DEVELOPMENT APPLICATION No D - 1340/2006

Project :- Alterations to Parkhurst Tavern - North Rockhampton

Subject :- Response to Information Request

## Existing Site Plan

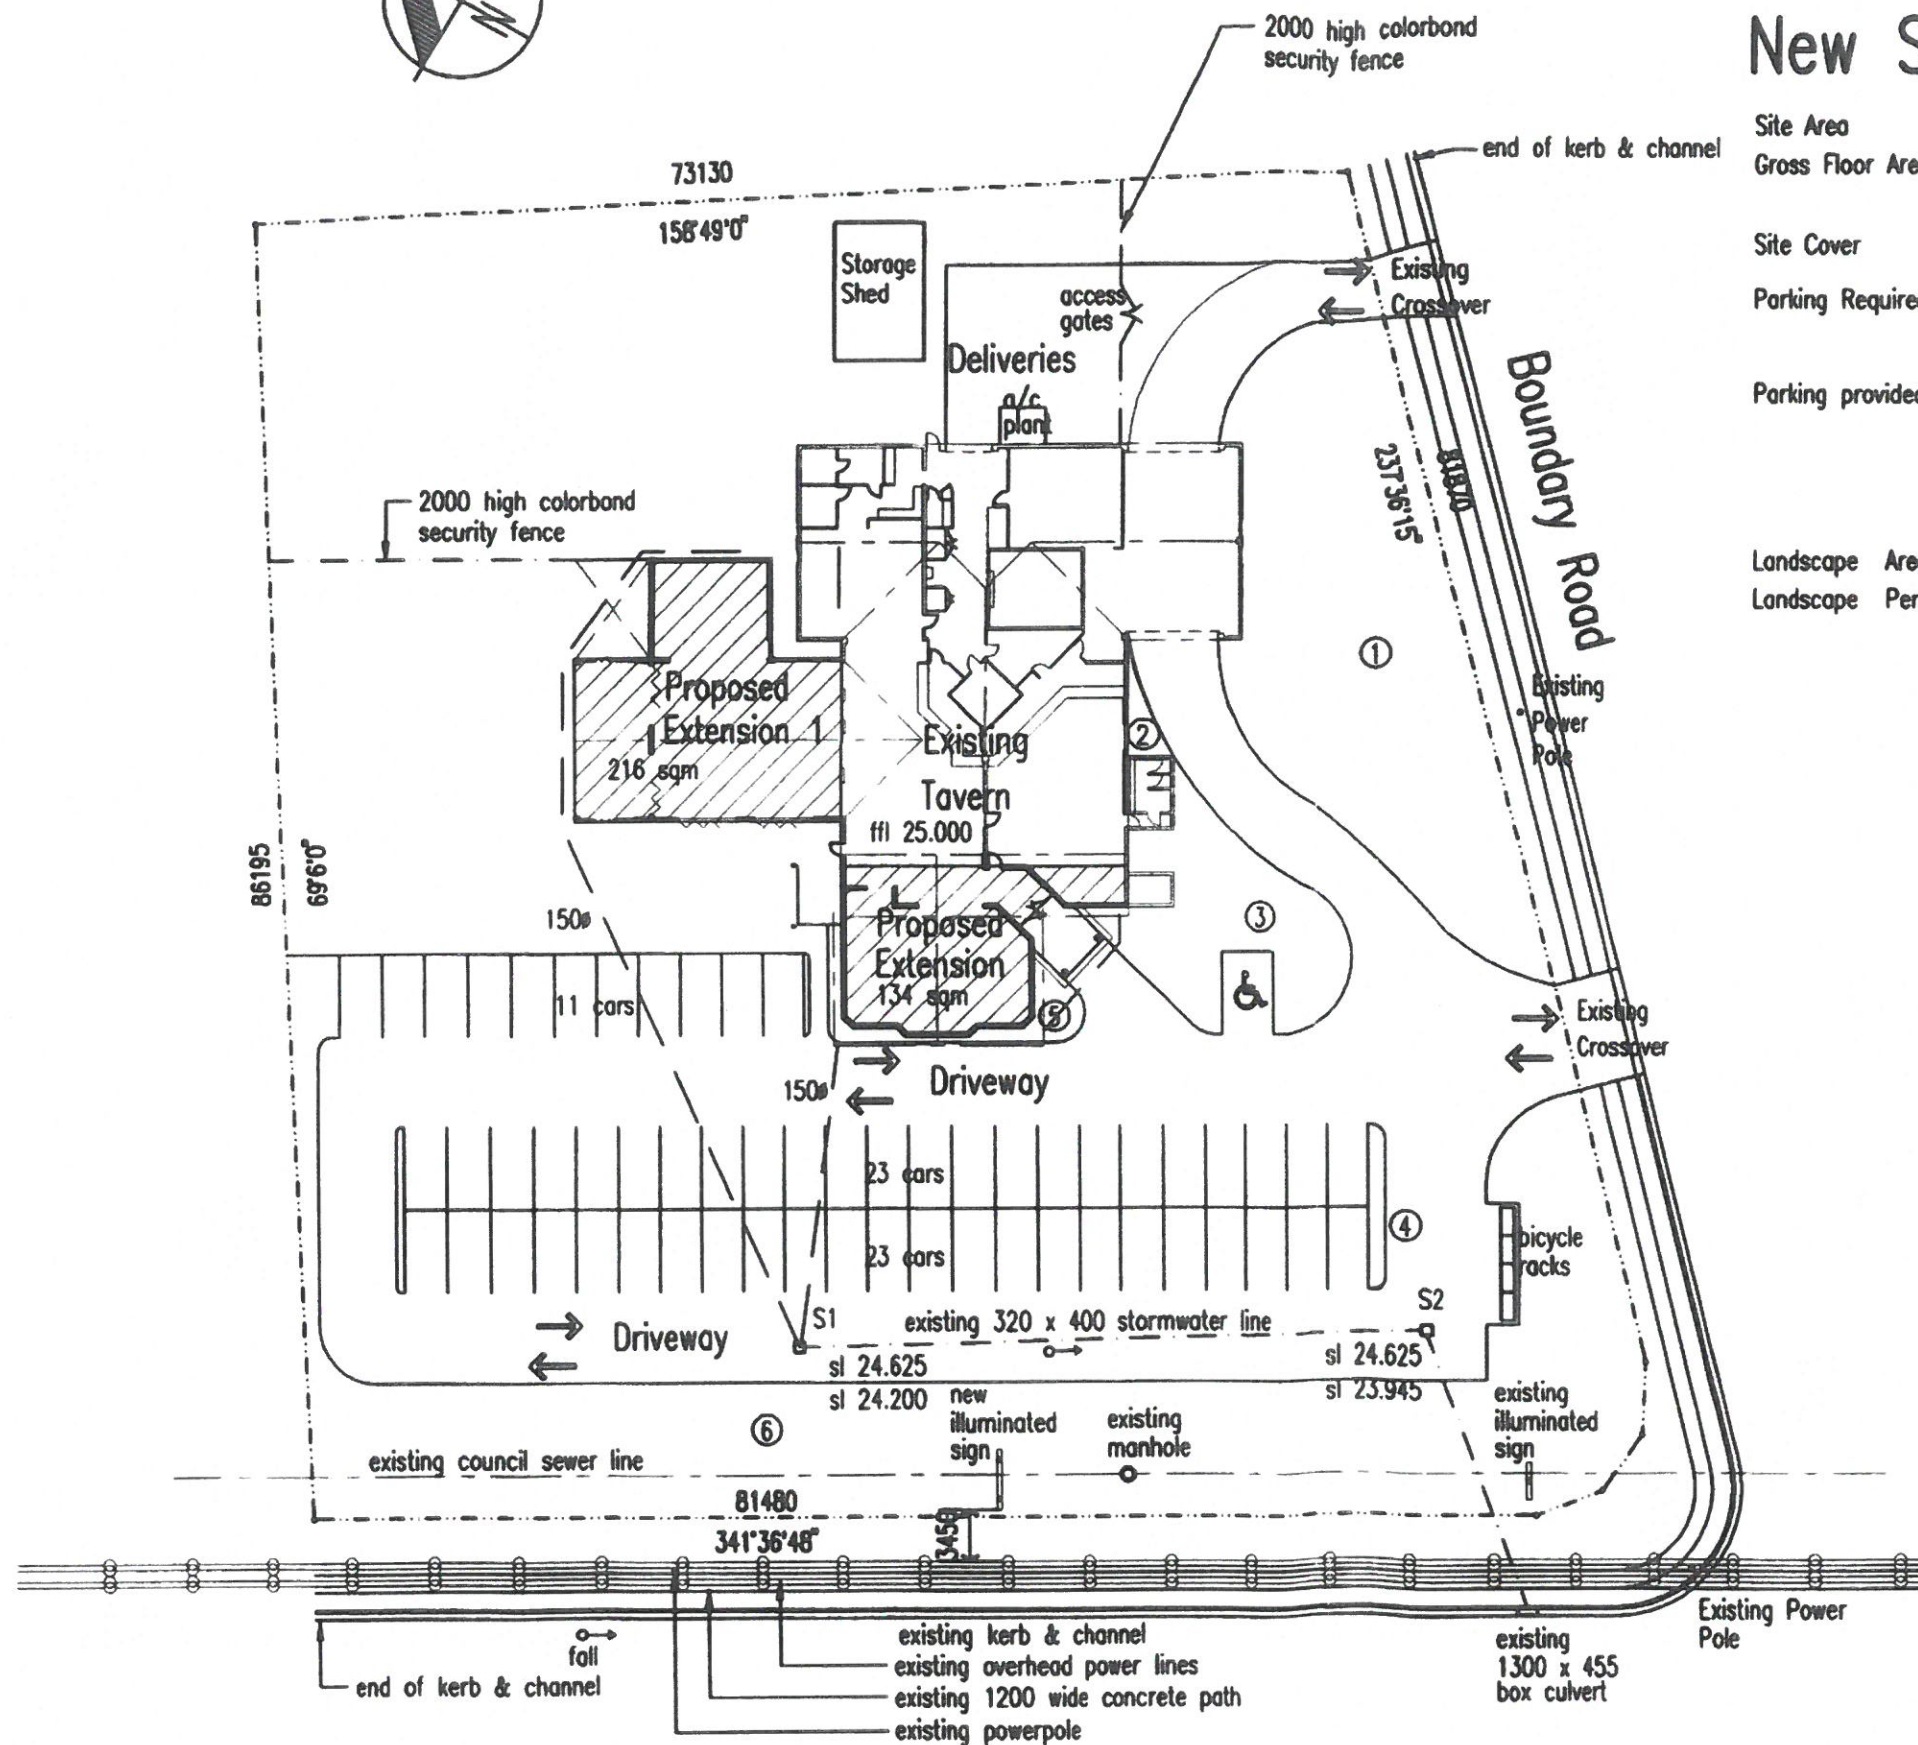
Item 6 When you visit the site you will find that the landscaping noted on the existing and proposed drawings are the same and have been established for between 10 & 13 years. We have 24% of the site landscaped which 14% more than required. No new landscaping is planned.

# Proposed Site Plan

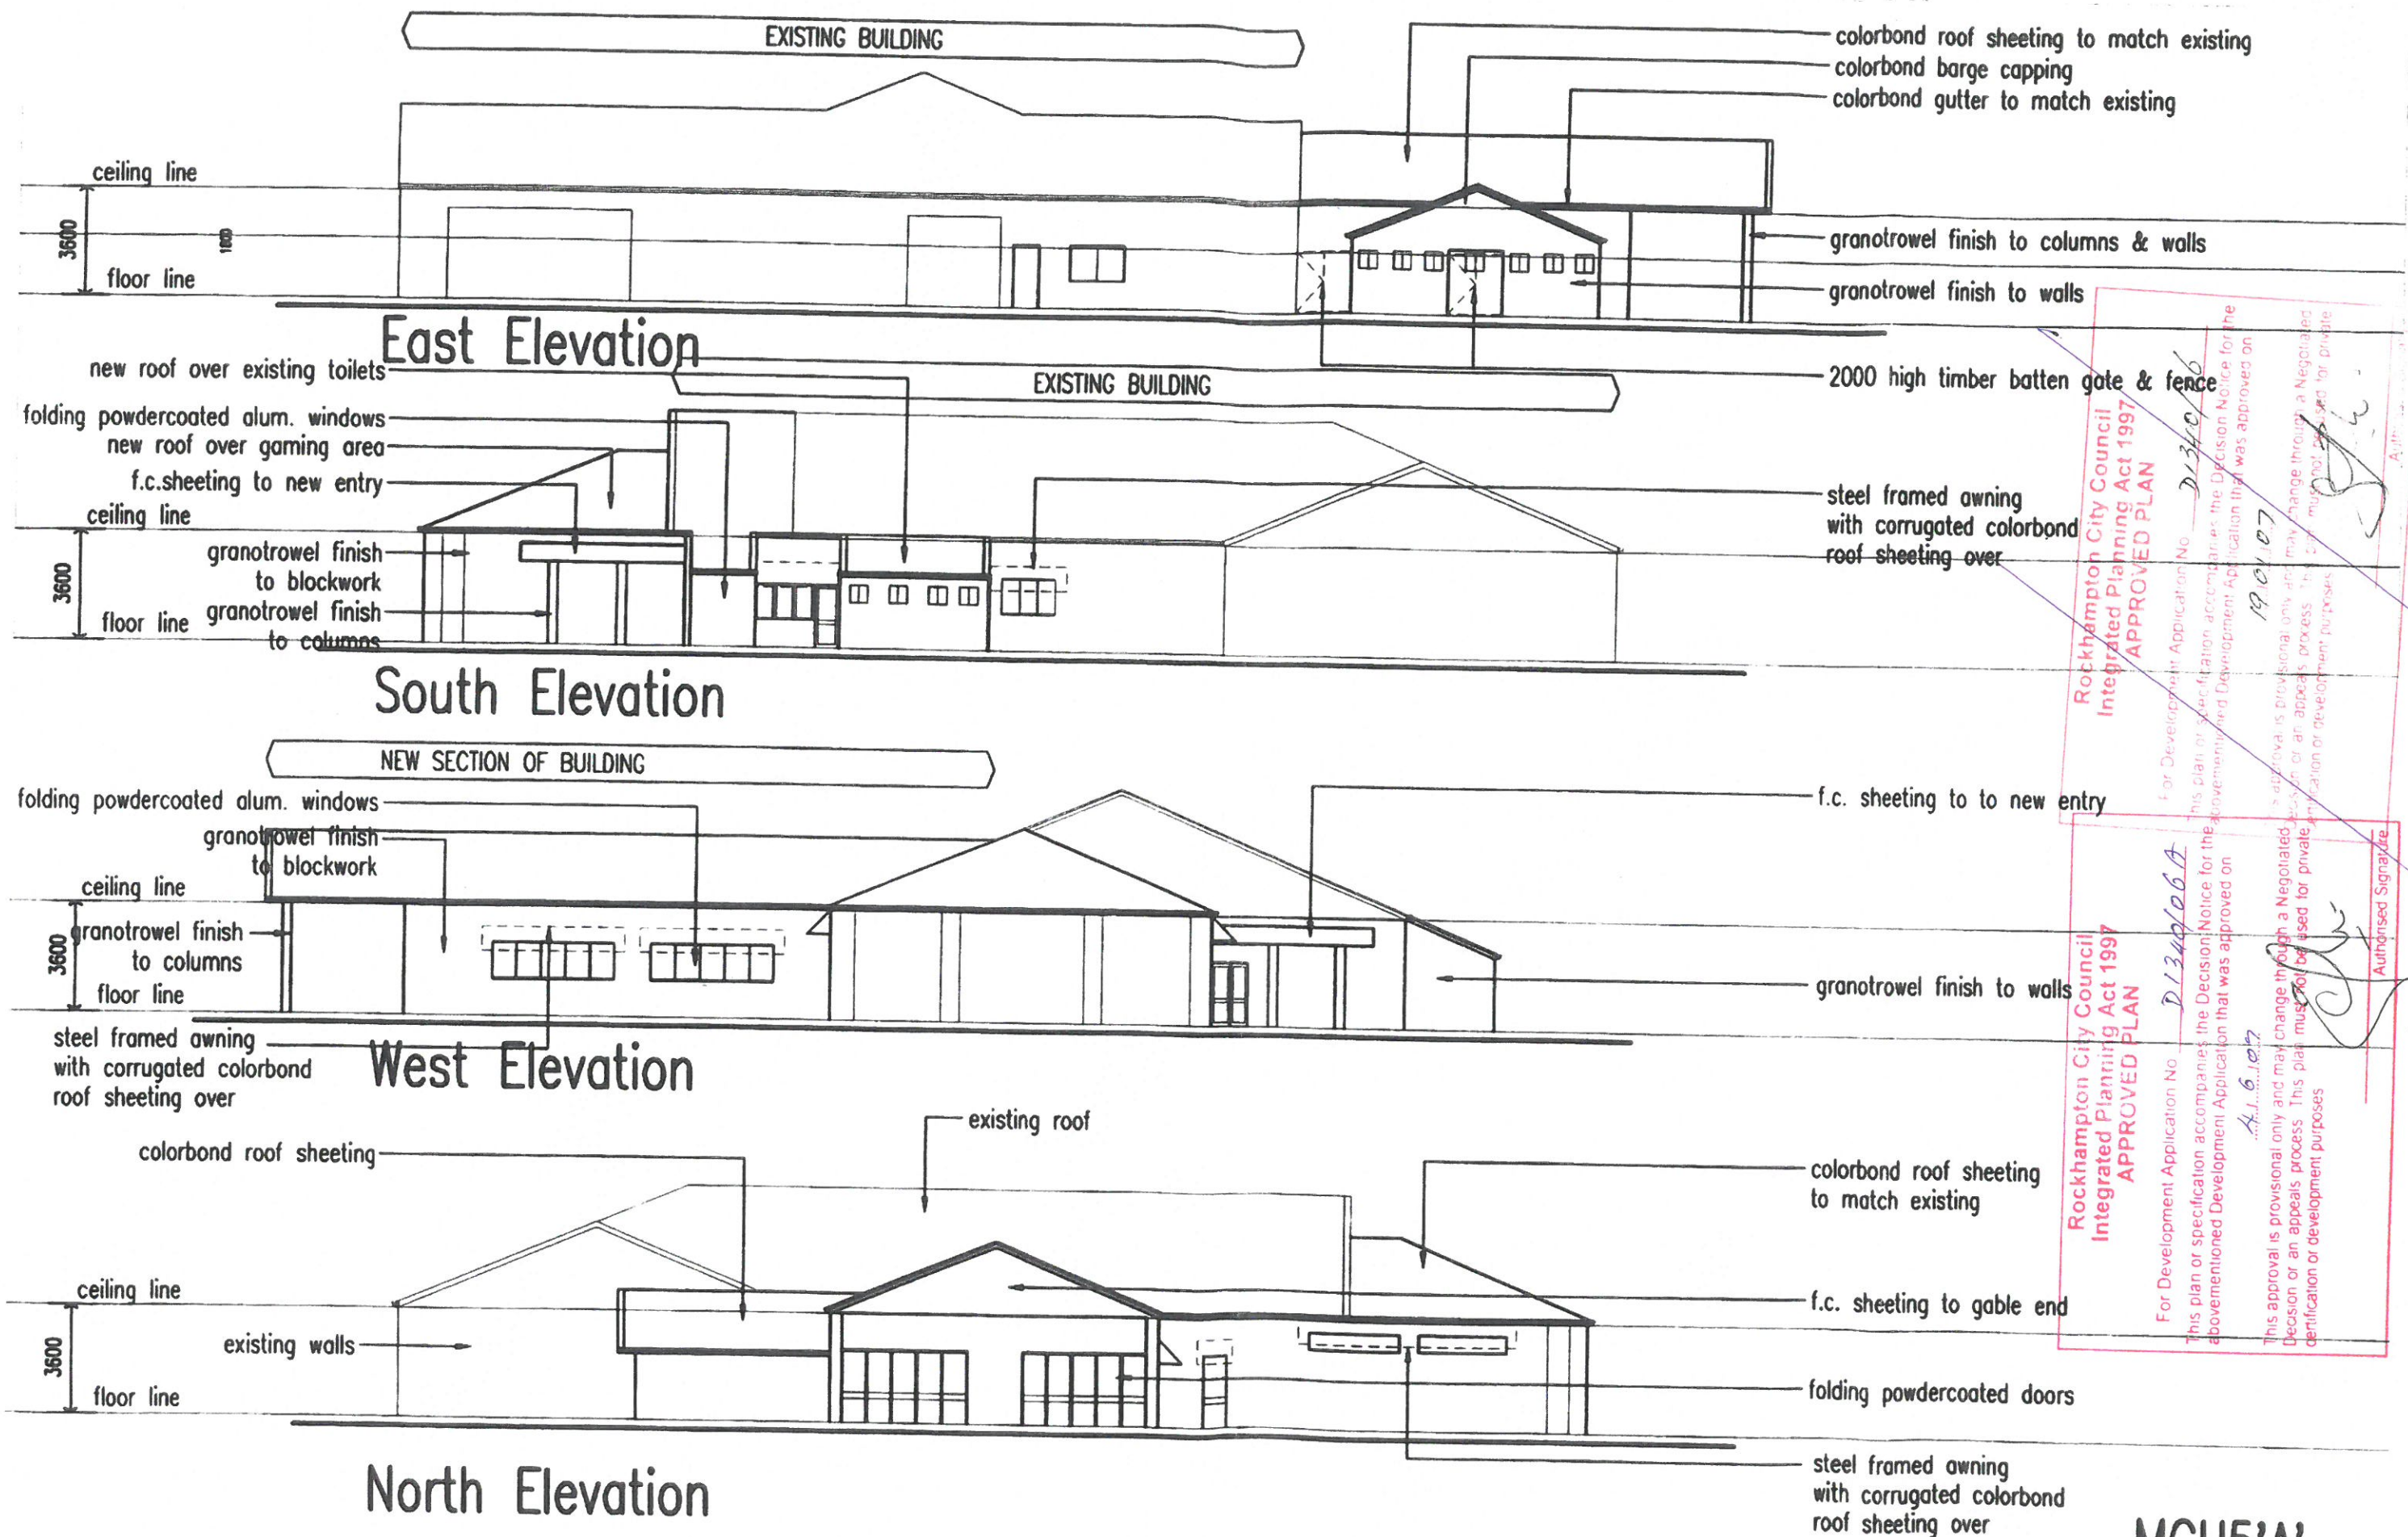
Item 5 We have shown an area for the location of 30 bicycles on the amended site plan as required by Parking & Access Code. and will be implement the requirement.
